MFN 16-008

Response to Request for Additional Information Regarding Review of
Licensing Topical Reports NEDE-33005P and NEDO-33005,
“Licensing Topical Report TRACG Application for Emergency Core
Cooling Systems / Loss-of-Coolant-Accident Analyses for BWR/2-6”

SNPB RAI-67

Figure R82-1 Spray Cooling Experiment Setup

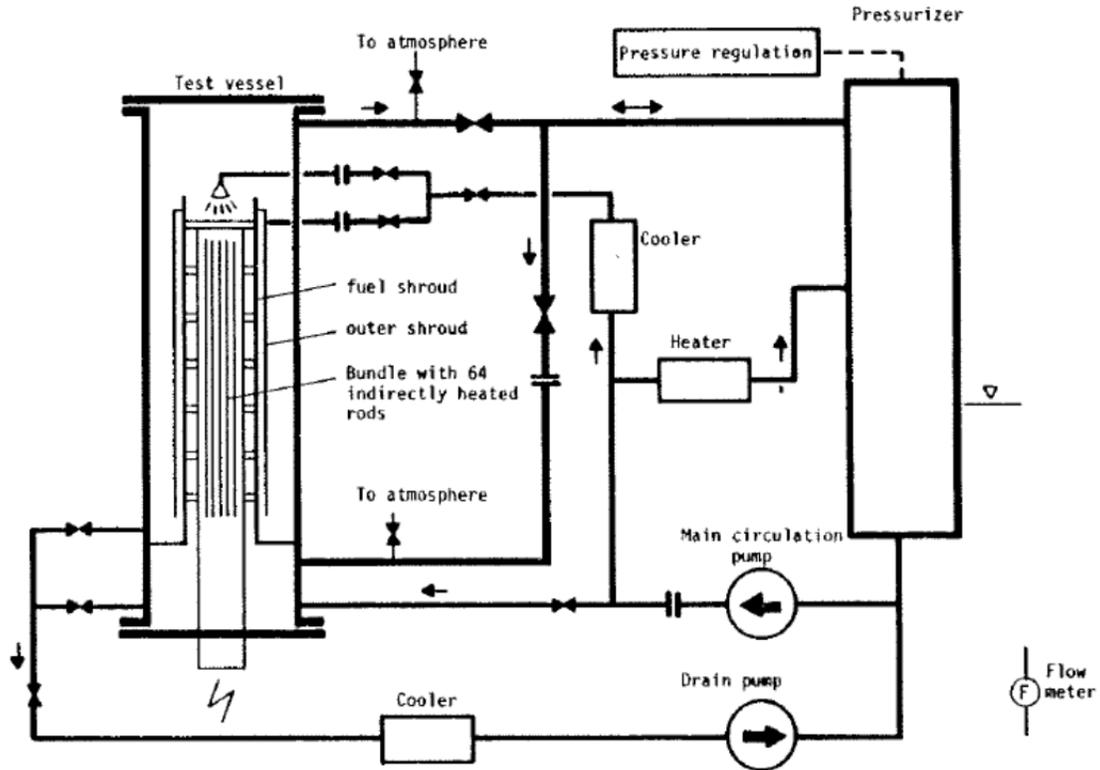
The core spray test comparisons described in Section 7.4 of the TRACG LOCA LTR include the phenomenological interactions relevant for the ECCS portion of a LOCA in a non-jetpump BWR. Selected comparison of calculated and measured rod temperatures shown in the LOCA LTR demonstrate that the uncertainties considered are sufficient. Additional core spray results were provided in the response to RAI-92. Even more additional experimental data are evaluated here as part of this response. The additional data supplied in this response comes from the Studsvik core spray heat transfer tests (Reference R82-5). The facility could be configured in different ways. As shown in Figure R82-1, the setup for the core spray heat transfer tests allowed bottom venting. The vents were open to atmosphere. Although the tests were not aimed to study air effects, during the venting, it was possible for air to enter the test rig unrestricted.

A series of tests were conducted top and bottom venting configurations. The test run 123 was specifically designed as bottom vented. No measurements were made to determine how much air was ingested; however, the TRACG calculations for this test indicate [[
